STORMWATER MANAGEMENT PLAN & DRAINAGE ANALYSIS

**6 Cannato Place
Town of North Castle - New York**

**June 1, 2023
Revised August 4, 2023
Revised September 21, 2023**

We have received your comment memo dated July 5, 2023, and offer the following responses on behalf of the applicant. Responses are in bold.

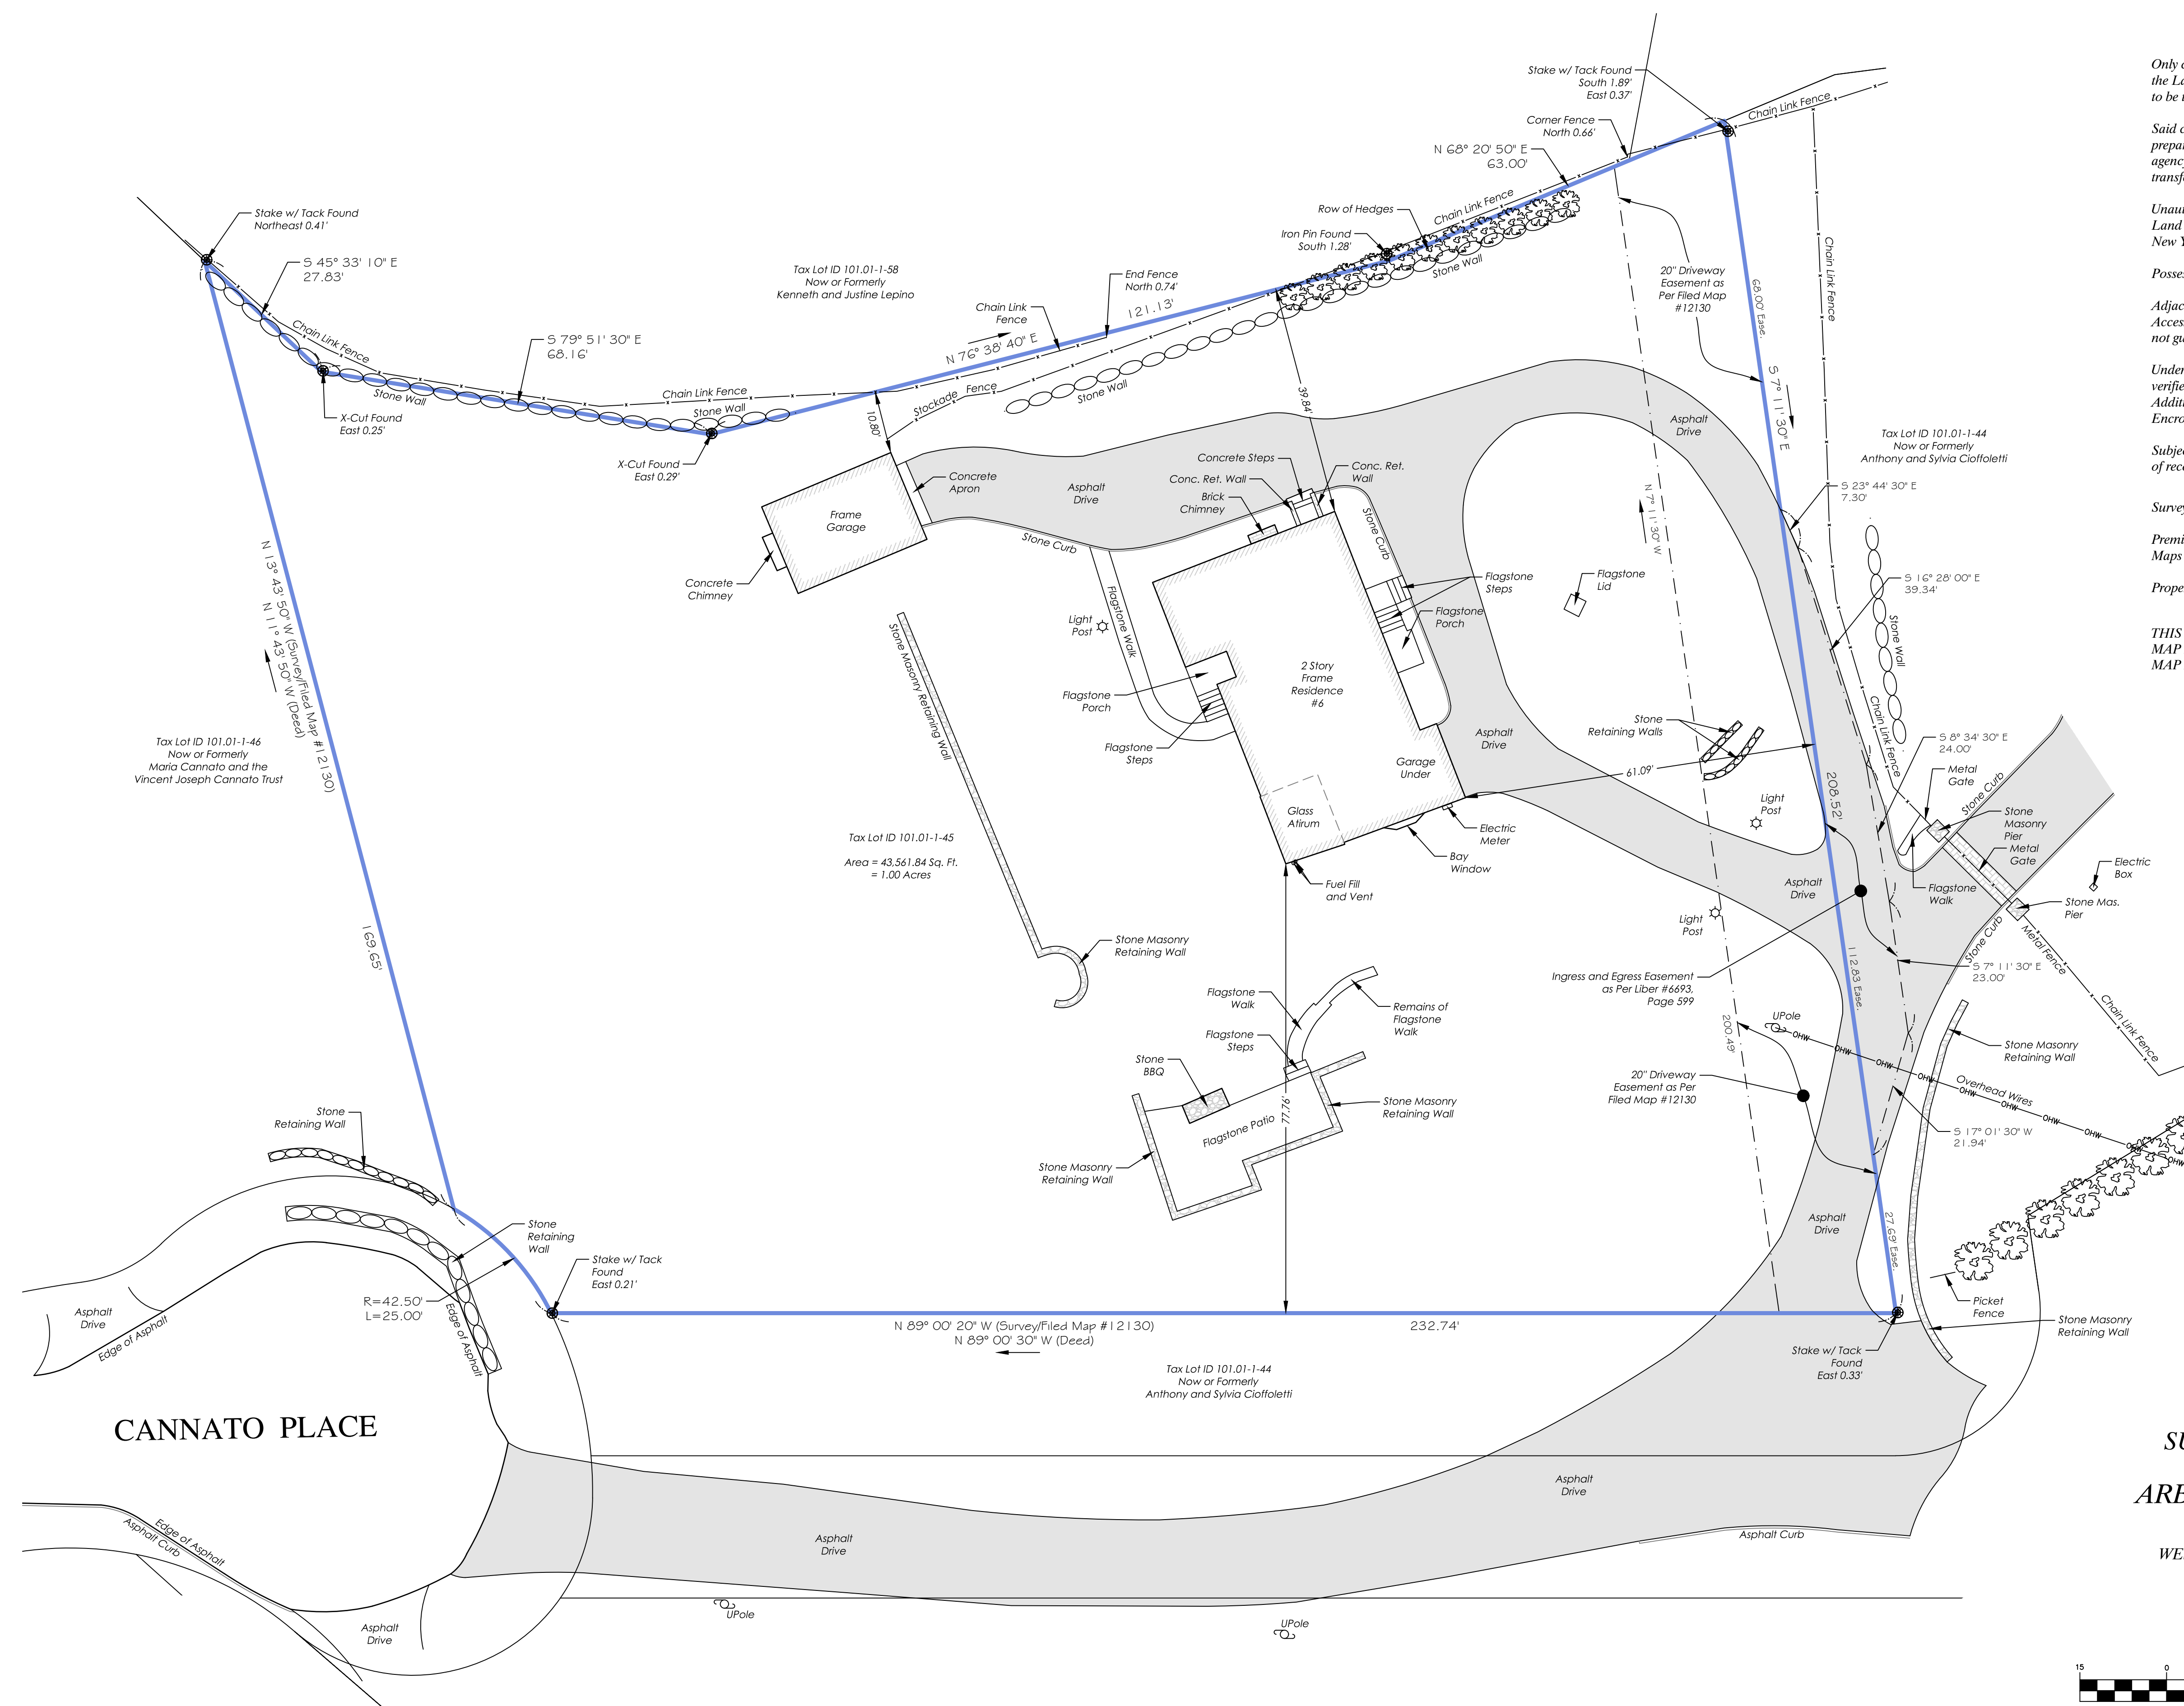
18. The applicant will need to provide a copy of the Westchester County Department of Health (WCHD) Approval for the proposed on-site wastewater treatment system and drilled well.

OWTS and Private Well plans are currently being reviewed by WCHD. A copy of approval will be provided upon availability.

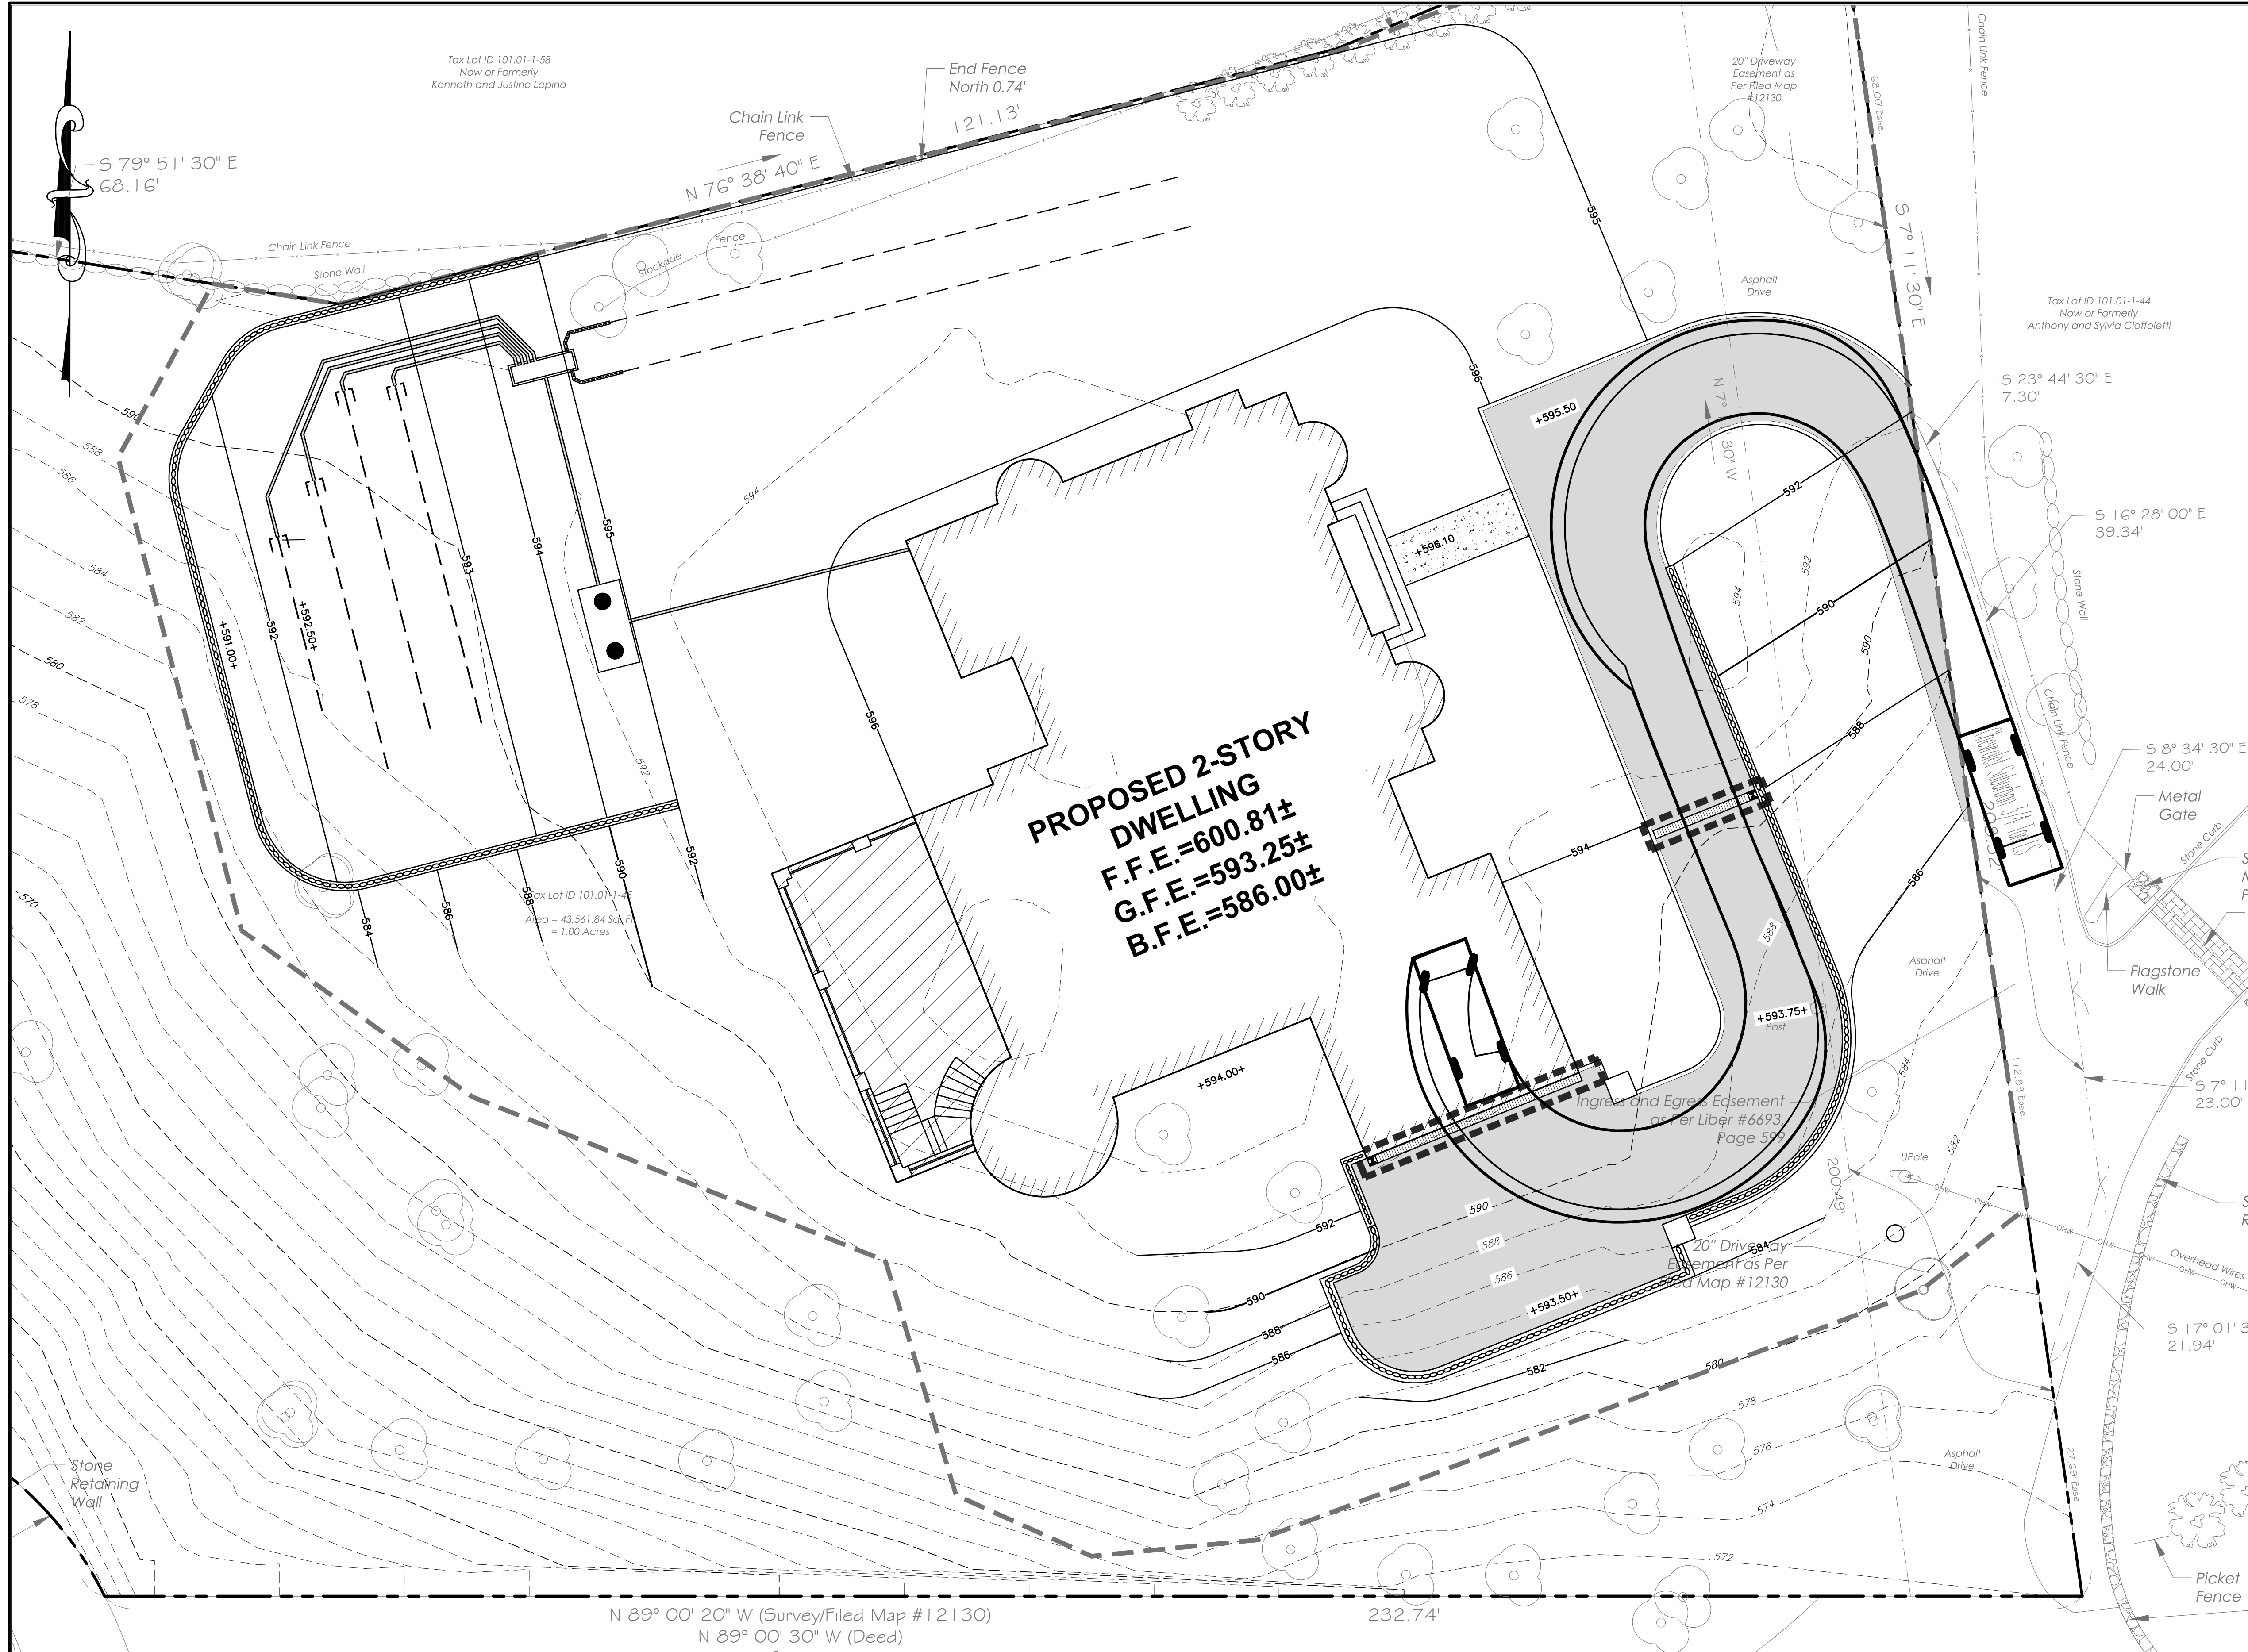
8. The applicant shall provide stormwater mitigation and design calculations for the runoff generated by the net increase in impervious surface for the 100-year, 24-hour design storm.

See sheet C-3, Stormwater Management Plan. The proposed 12x12 catch basin upstream of the proposed Cultec units acts as an overflow should exfiltration rates fail to keep up with the storm event.

Please note the lower patio is covered by a first-floor patio which is tributary to the proposed Cultec system. See sheet C-3, Stormwater Management Plan.
